## THE RANCH SKETCH PLAN

SKP18-006

#### Markup Summary

**COVER SHEET**

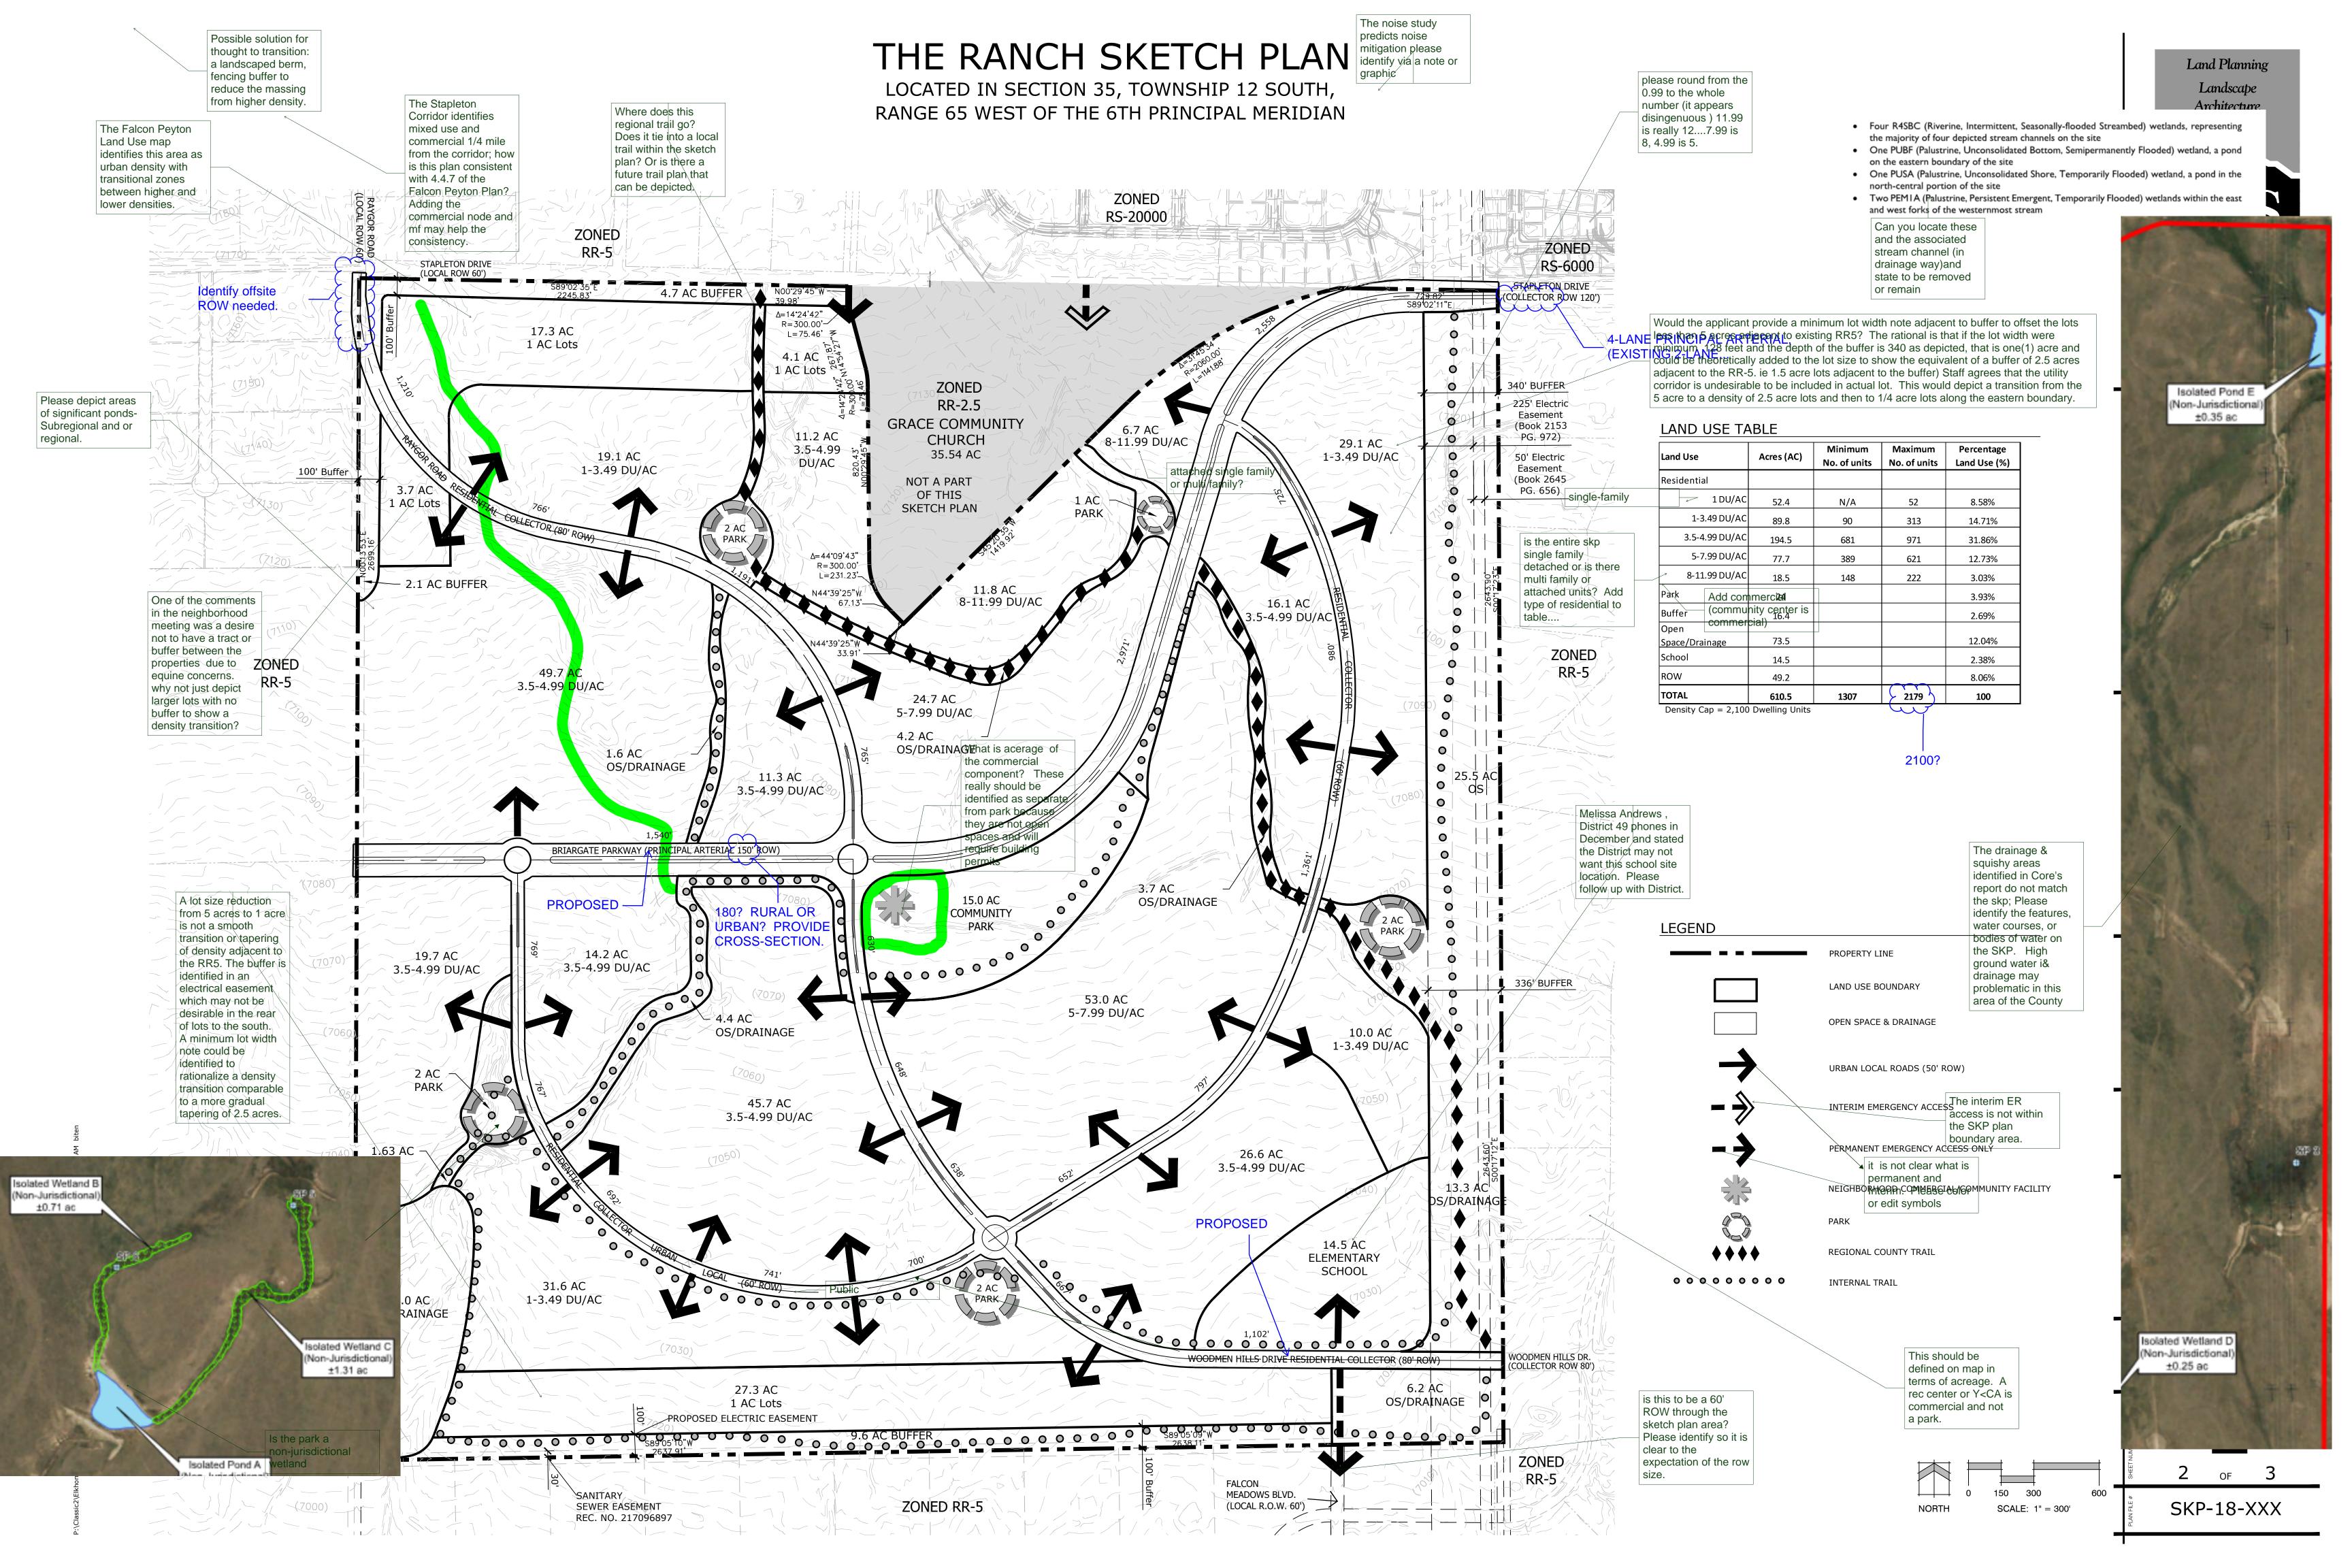
see comments on next sheet

What do you mean here? If you have a bubble thats ay 1-4 du / ac then the max density would be

Will you have two pints of access? Stapleton is one access point.

please provide documentation that is recent identifying the school is ok wit this location.

Is this agreement still valid with the moving of Stapleton?

A PUD Modification and Or

# THE RANCH SKETCH PLAN

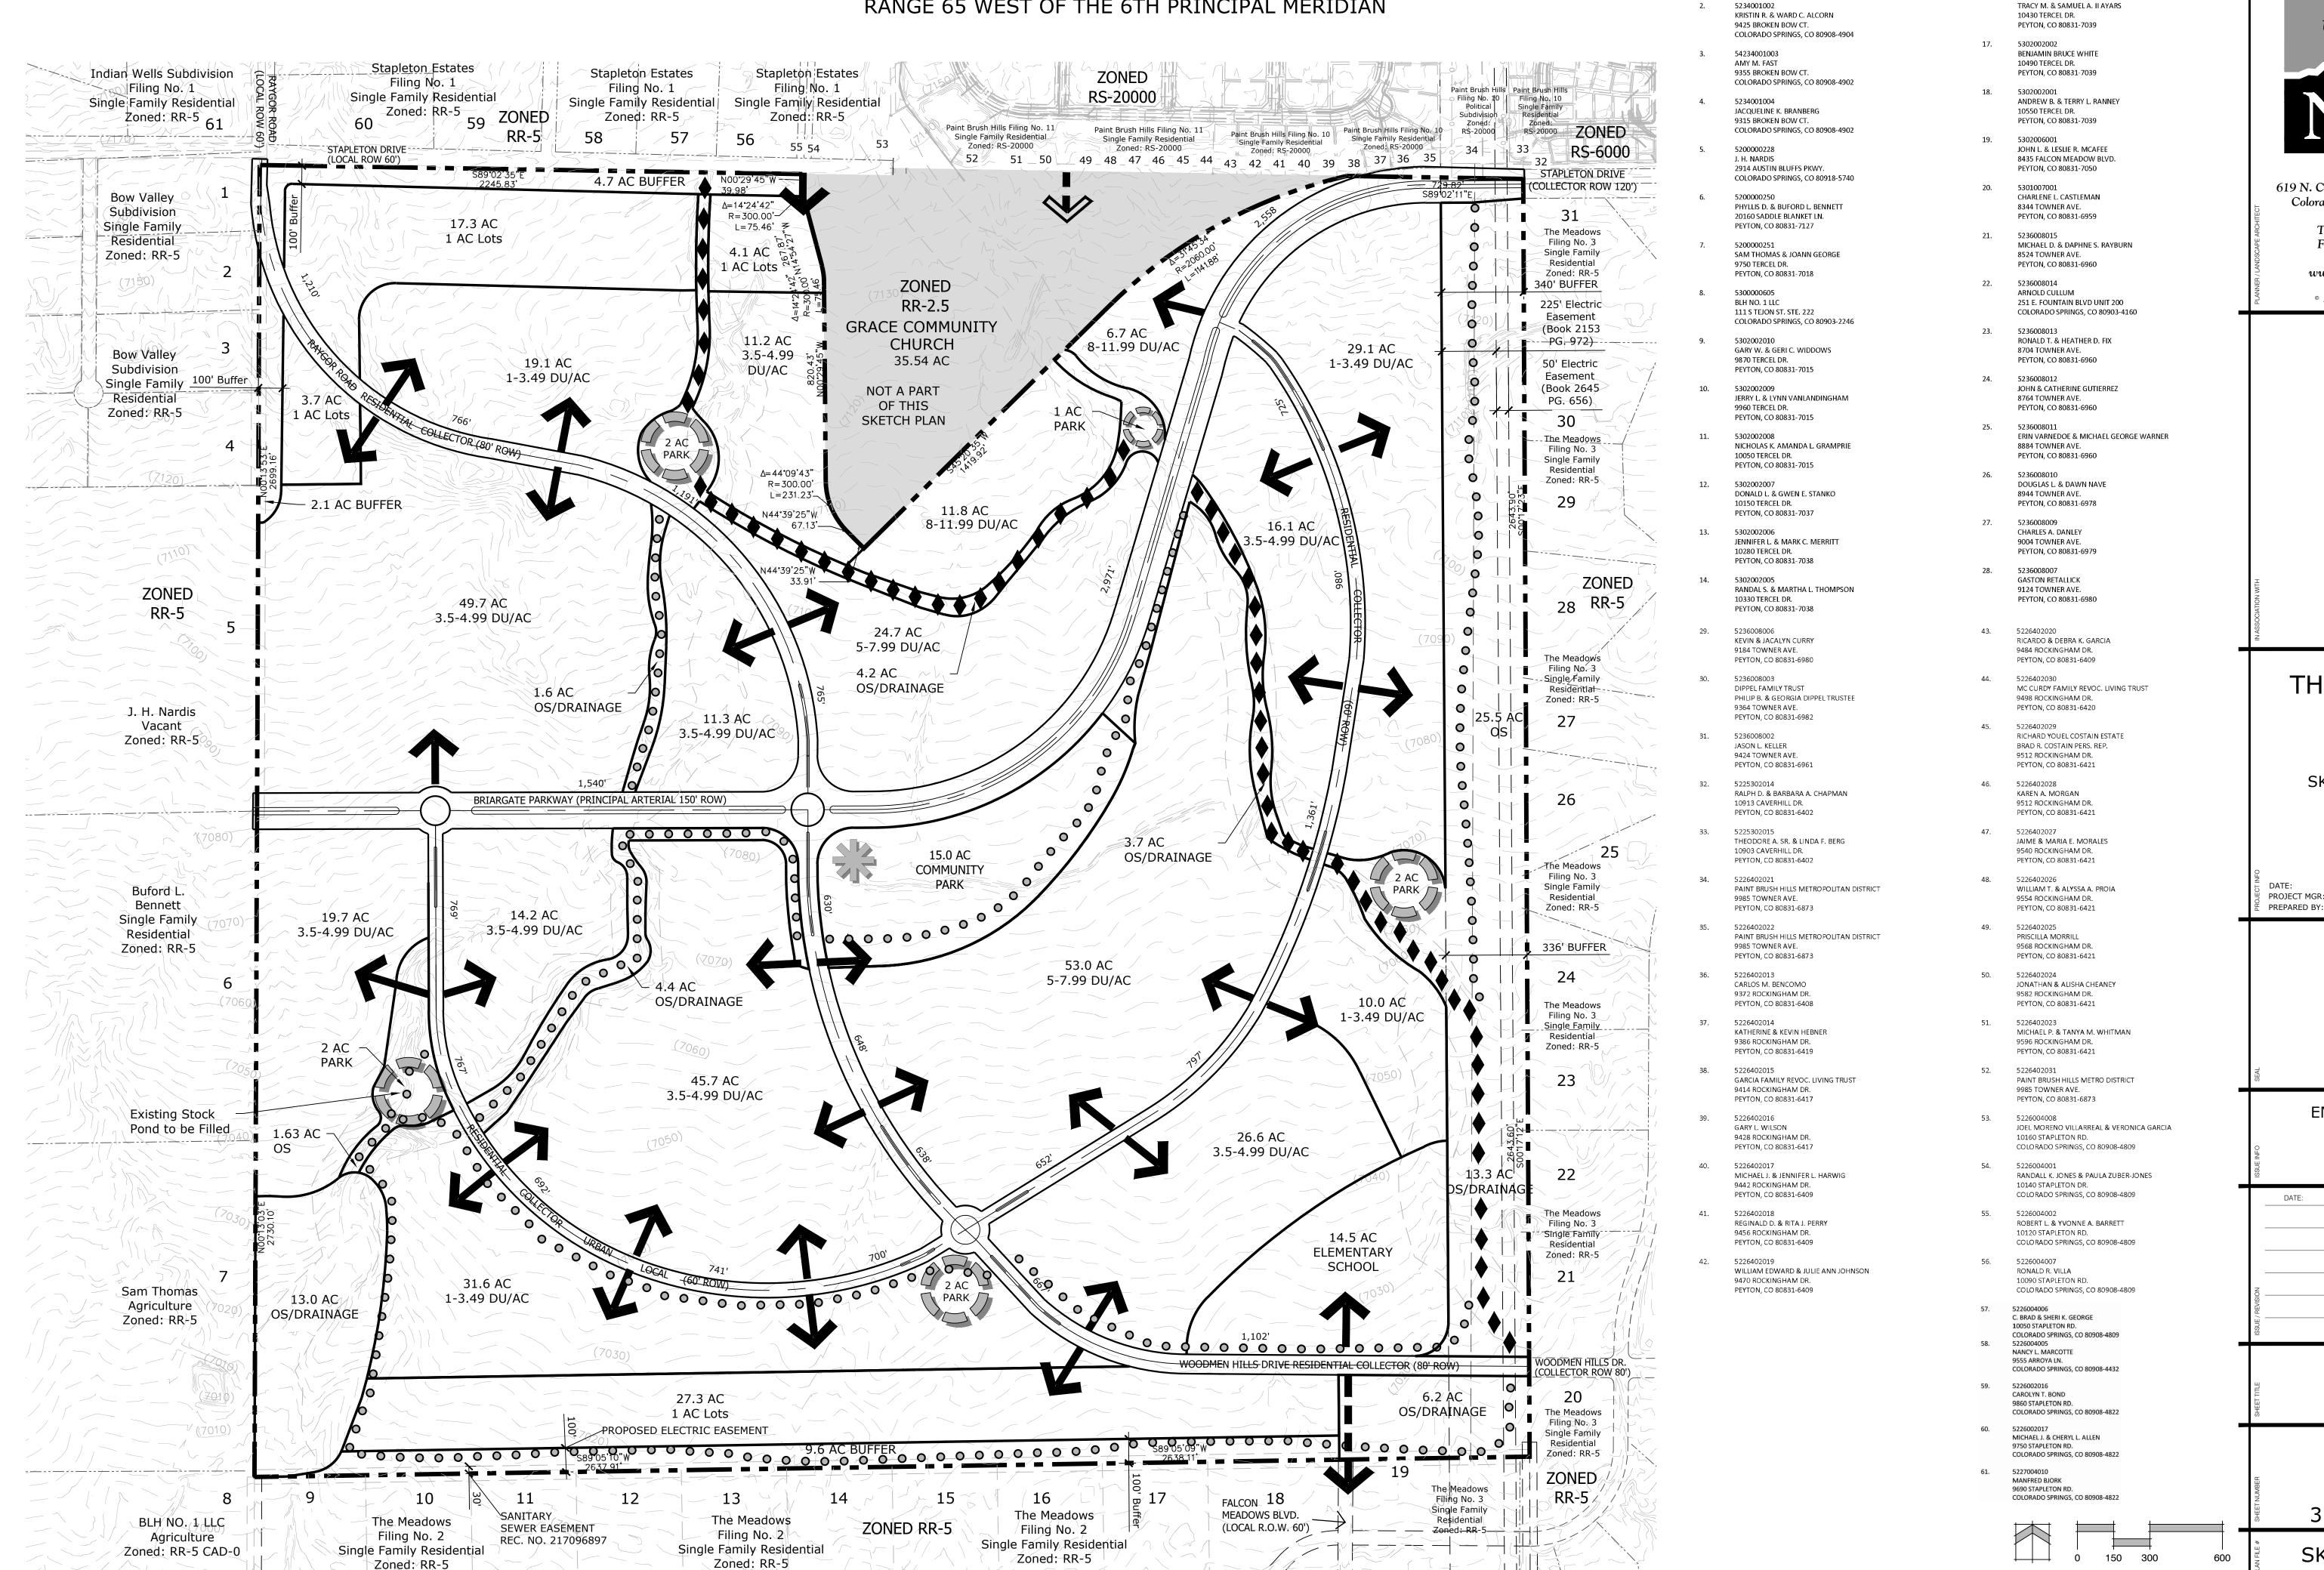
The Falcon Peyton Land Use map identifies this area as urban density with transitional zones between higher and lower densities.

The Stapleton Corridor identifies mixed use and commercial 1/4 mile from the corridor; how is this plan consistent with 4.4.7 of the Falcon Peyton Plan? Adding the commercial node and mf may

Please depict areas of significant ponds-Subregional and or regional.

Melissa Andrews, District 49 phones in December and stated the District may not want this school site location. Please follow up with District.

is this to be a 60' ROW through the sketch plan area? Please identify so it is clear to the

Where does this regional trail go? Does it tie into a local trail within the sketch plan? Or is there a

The interim ER access is not within the SKP plan boundary area.

it is not clear what is permanent and Interim. Please color or edit symbols

What is acerage of the commercial component? These really should be identified as separate from park because they are not open spaces and will

is the entire skp single family detached or is there multi family or attached units? Add type of

Add commercial (community center is commercial)

please round from the 0.99 to the whole number (it appears disingenuous ) 11.99 is really 12....7.99 is

attached single family or multi family?

A lot size reduction from 5 acres to 1 acre is not a smooth transition or tapering of density adjacent to the RR5. The buffer is identified in an electrical easement which may not be desirable in the rear of lots to the south. A minimum lot width note could be identified to rationalize a density transition comparable to a more gradual tapering of 2.5 acres.

One of the comments in the neighborhood meeting was a desire not to have a tract or buffer between the properties due to equine concerns. why not just depict larger lots with no buffer to show a

This should be defined on map in terms of acreage. A rec center or Y<CA is commercial and not a park.

Is the park a non-jurisdictional wetland

Would the applicant provide a minimum lot width note adjacent to buffer to offset the lots less than 5 acres adjacent to existing RR5? The rational is that if the lot width were minimum 128 feet and the depth of the buffer is 340 as depicted, that is one(1) acre and could be theoretically added to the lot size to show the equivalent of a buffer of 2.5 acres adjacent to the RR-5. ie 1.5 acre lots adjacent to the buffer) Staff agrees that the utility corridor is undesirable to be included in actual lot. This would depict a transition from the 5 acre to a density of 2.5 acre lots and then to 1/4 acre lots along the eastern boundary.

The drainage & squishy areas identified in Core's report do not match the skp; Please identify the features, water courses, or bodies of water on the SKP. High ground water i& drainage may

Identify offsite ROW needed.
